ADDENDUM NUMBER TWO (2)
PROJECT NUMBER: RFP #2026-03

Madera County Riverstone Fire Station

REQUEST FOR CLARIFICATIONS (RFCs):

42 TILE WAINSCOT PATTERN
SCALE: 3/4" = 1'-0"

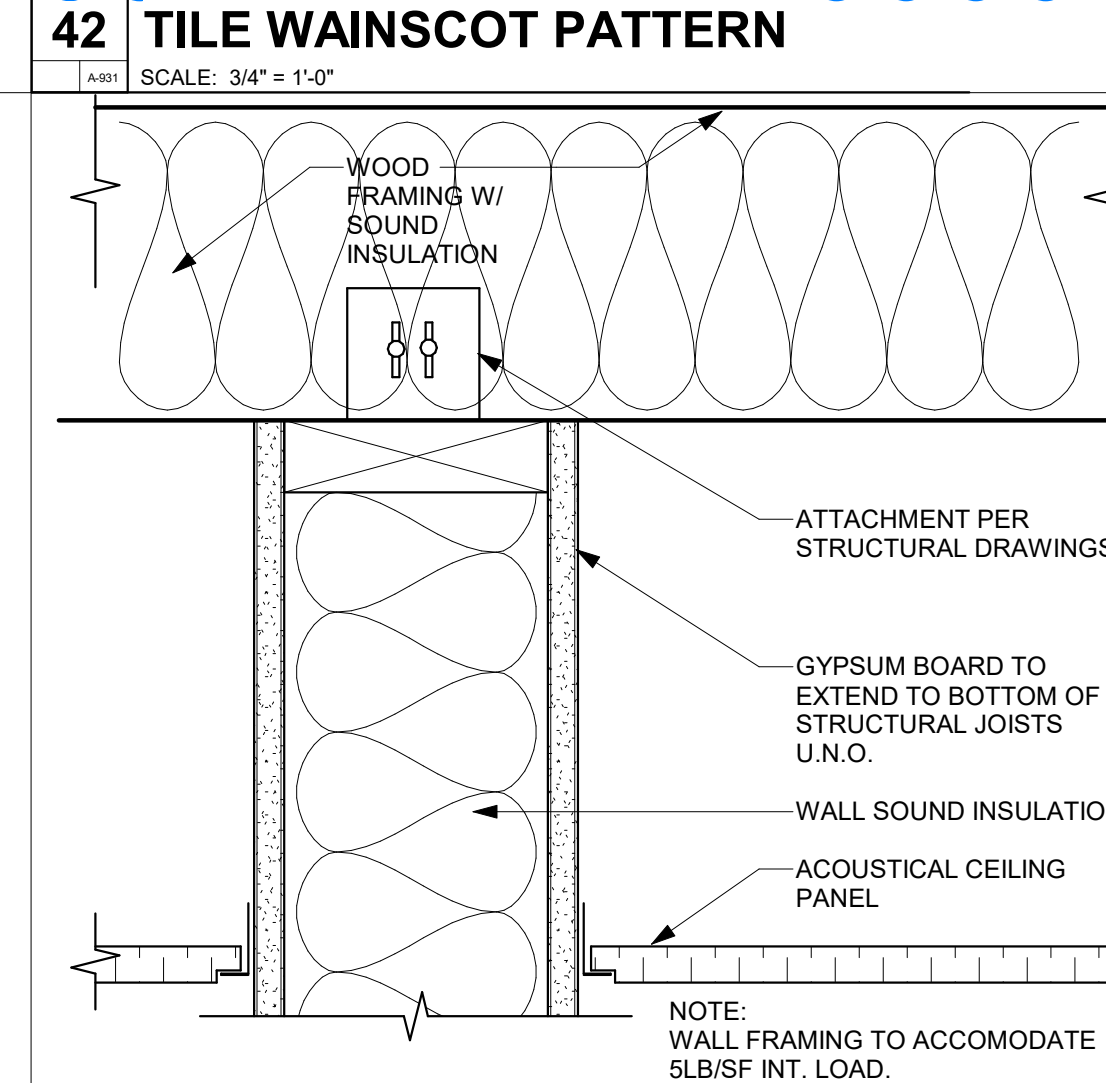
As per Finish Legend A-131, the field wall tile (T-2) is noted as 6"x24". However, Detail A-931/42 indicates a 12"x24" tile. Could you please confirm the correct size of the field tile?

As per Finish Legend A-131, the accent wall tile (T-3) is noted as a 6" band. However Detail A-931/42 indicates a 4" band. Could you please confirm whether the accent band should be 4" or 6"?

Use the sizing noted on sheet A-131. The callout on detail 42/A-931 has been revised to reflect a 1"x3" Tile Band.

11 BOLLARD - REMOVABLE
SCALE: 3/4" = 1'-0"

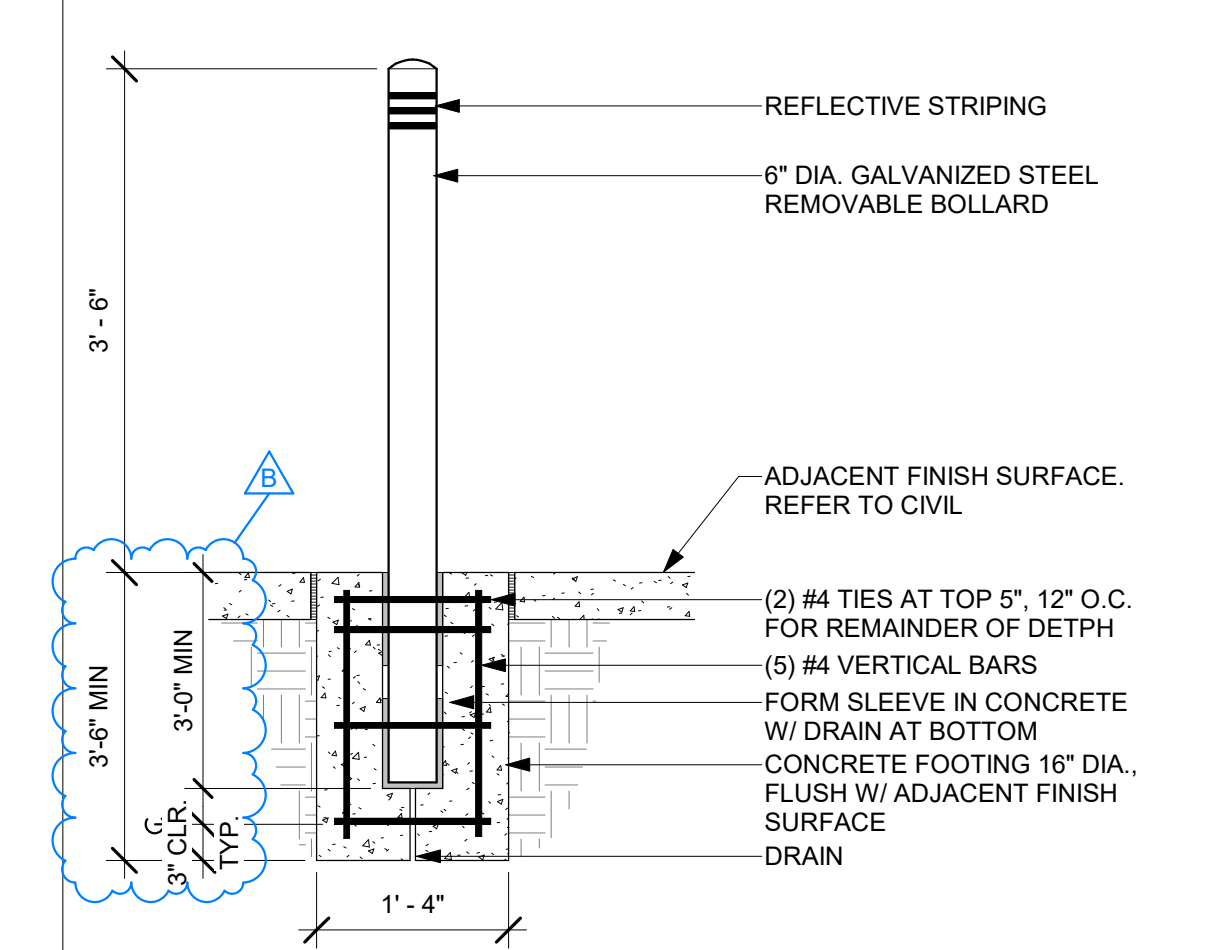
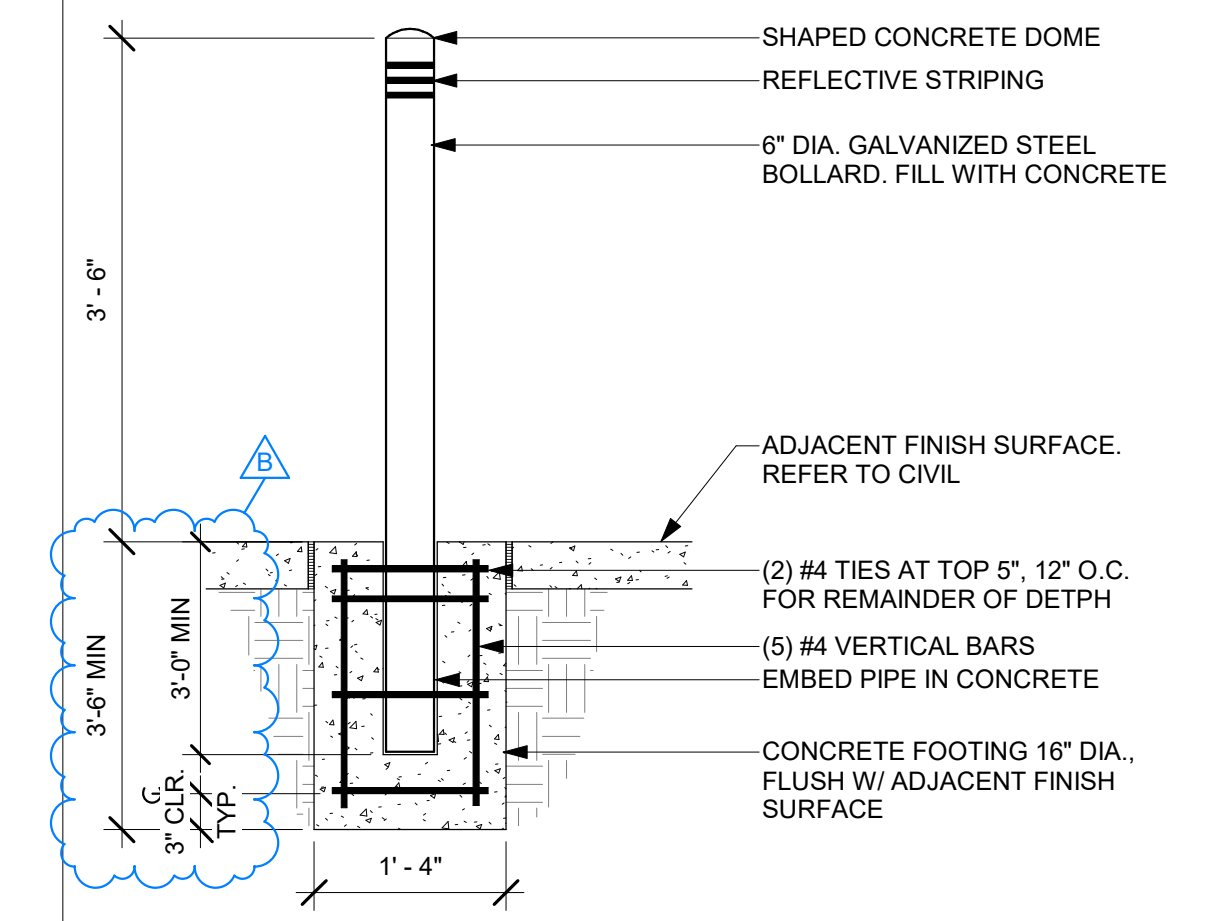
Please provide details for bollard.

Refer to details 11 & 12/A902. Refer to updated detail sheet AS902 included in this response.

1 EAST ELEVATION

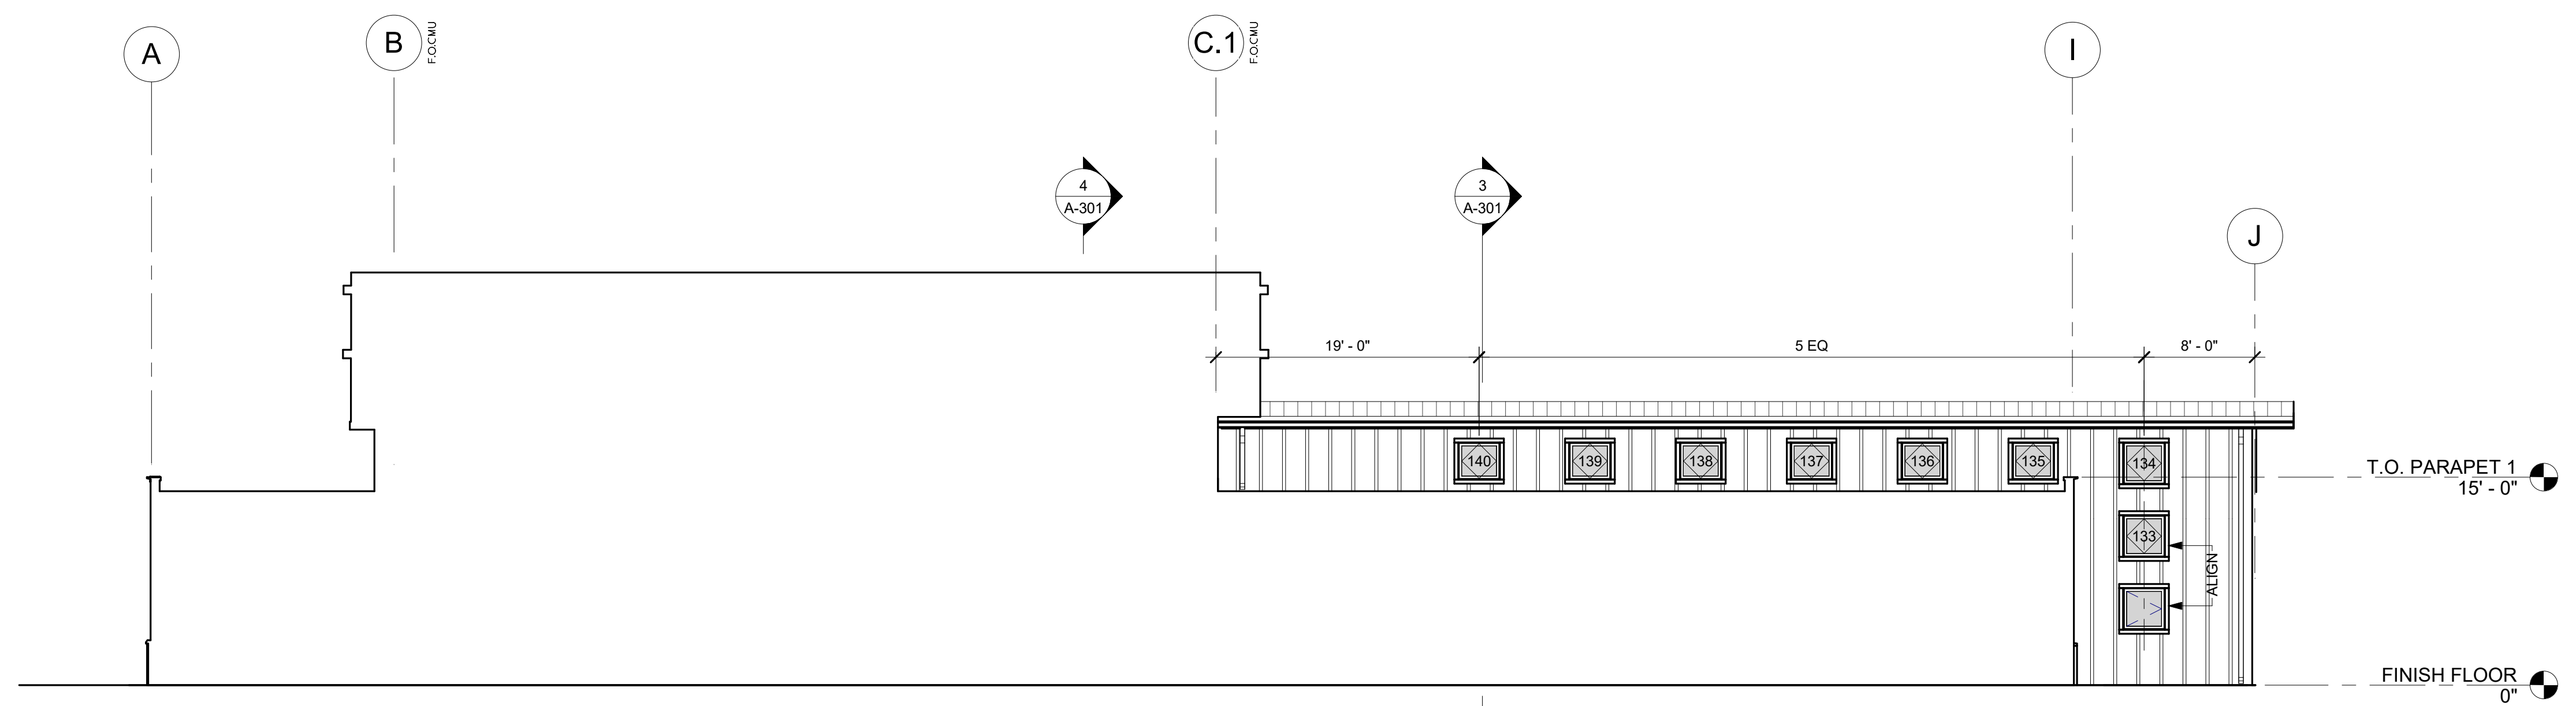
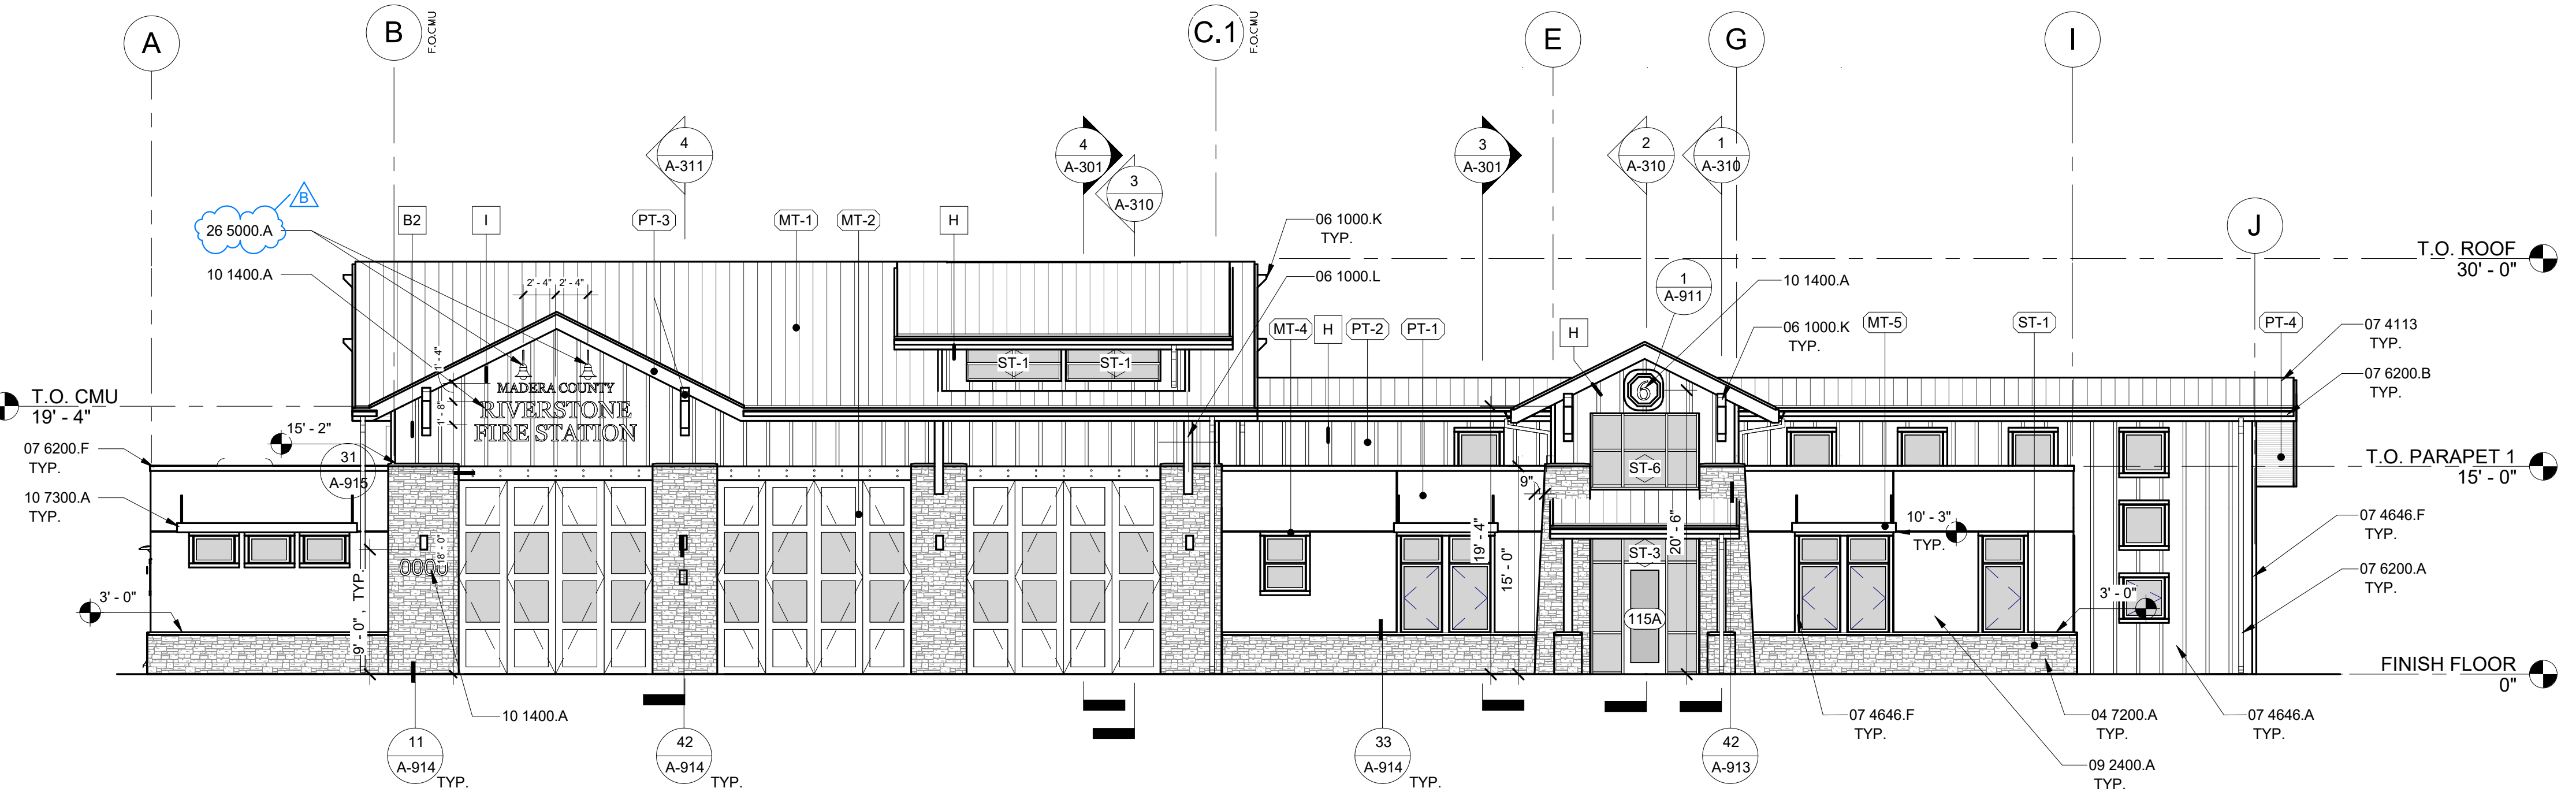
Please provide the Dimensional Letter Signage for this Section

Refer to updated section 10 1419. Also refer to the updated East Elevation on A-201 for added light fixtures and additional dimensions.
